TABLE 8: RIGHT TURN LANE ANALYSIS

The proposed San Tan 3 (New Retail Development and Indoor Batting Cages) is a planned commercial/retail development located on the southwest corner of Ocotillo Road and Kenworthy Road. The commercial/retail development will include a strip retail plaza, retail outparcel, and indoor batting cages and is planned to be constructed in one phase with full occupancy by 2025.

Public Works Traffic Engineering Review Comment Letter

Figure 5: Site Generated Traffic

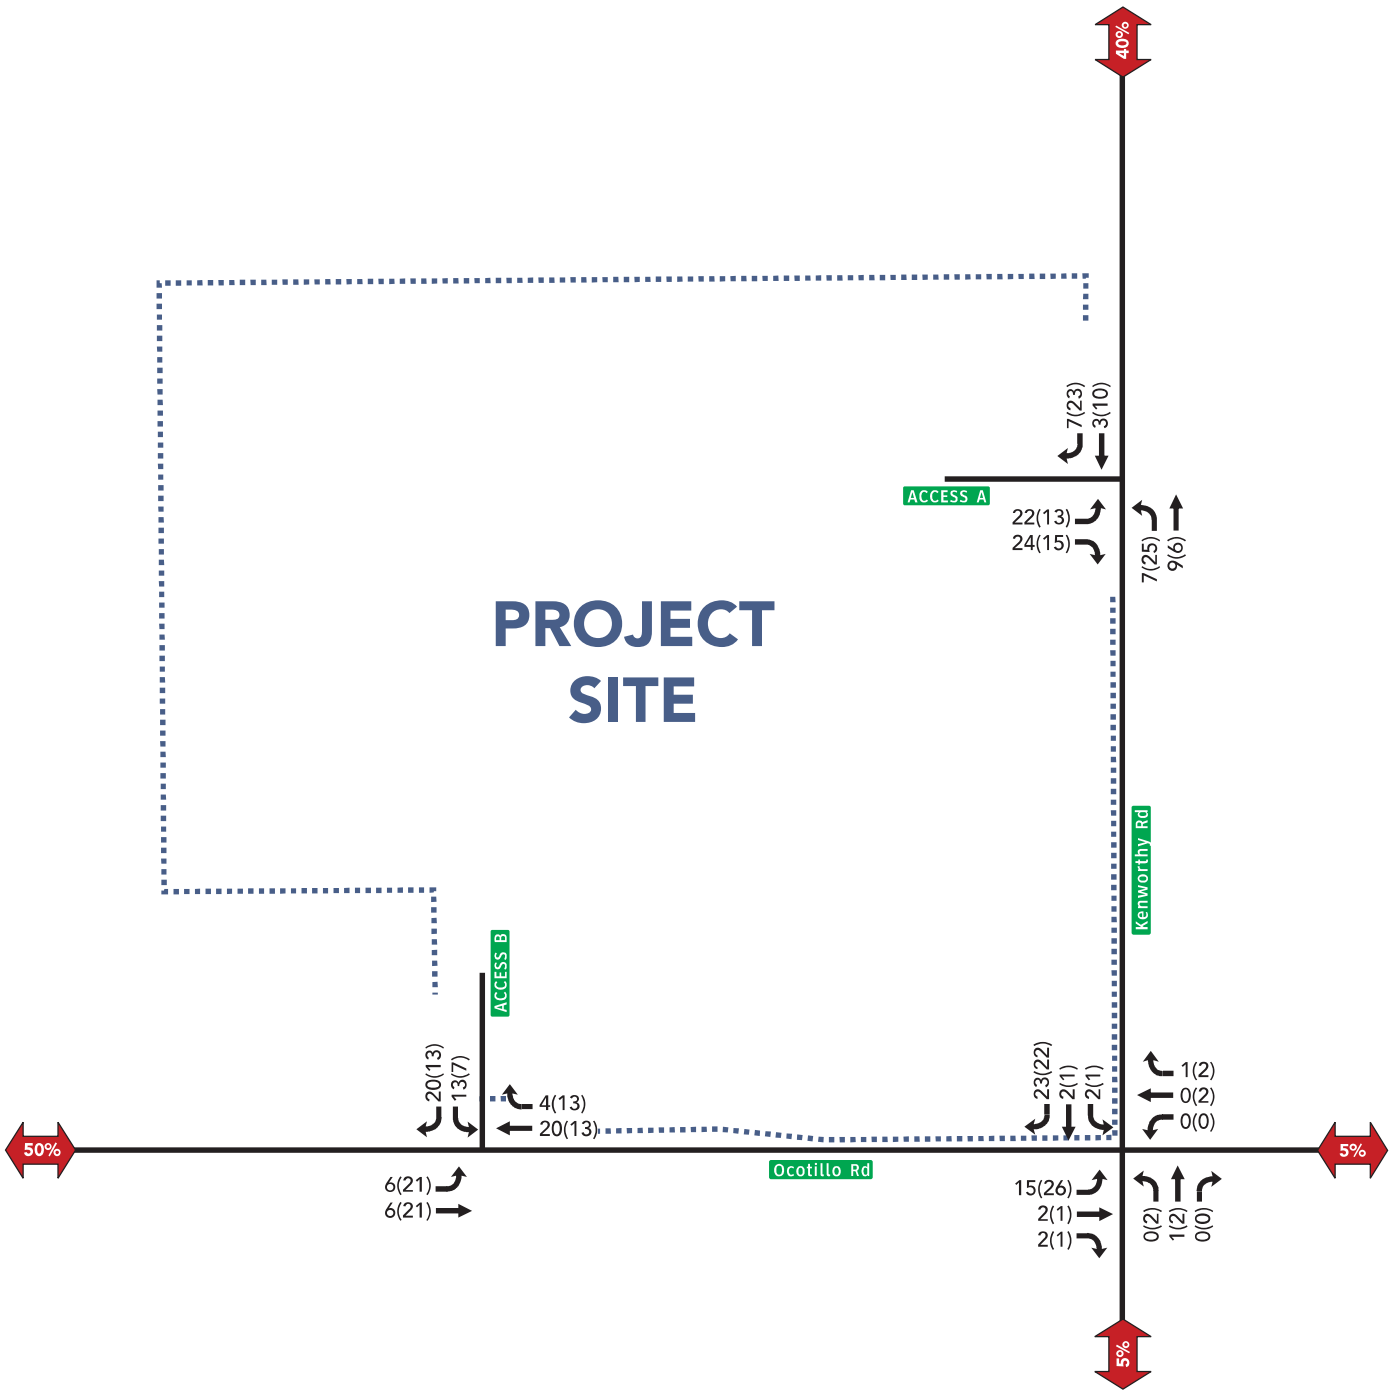
Figure	4	Since the report proposes at limited access (right-in, right-out) condition for both access A and B, how are there 10 AM vehicles and 37 PM vehicles heading NB on Kenworthy and WB on Ocotillo? See also previous comment. Moreover, the 10AM/37PM traffic shown on figure 5 does not appear to be actually entering or existing at access A or B. Is this a valid conclusion?
	5	All TIA's shall provide Average Daily Traffic (ADT) values for all study roadways for both existing and future traffic conditions in addition to the Peak Hour traffic Volumes in the report. Provide this information on the figures that show the AM/PM peak hour traffic volumes
	6	Because the traffic signal will not likely be installed anytime soon, please include a LOS analysis of the intersection for the unsignalized condition with your traffic generated from this site. Next, provide table comparing the unsignalized LOS for background traffic with the unsignalized LOS with the additional traffic from this site.

Figure 5	4	Vehicles were proposed to be making U-turns on Kenworthy Road and Ocotillo Road. The in and out volumes to and from the site are correct. However, with access changing, the trip distribution has been reallocated because Access B is proposed as a full turning movement access. Therefore, U-turns have been eliminated from the traffic modeling.
General	5	ADTs are added to the figures.
Page 29	6	Added LOS for Kenworth/Ocotillo controlled by all way stop and the comparison table for all way stop and signalized.
	7	Report updated to include the half street improvements and the raised median within the site boundary to limit Access A to right in/right out only
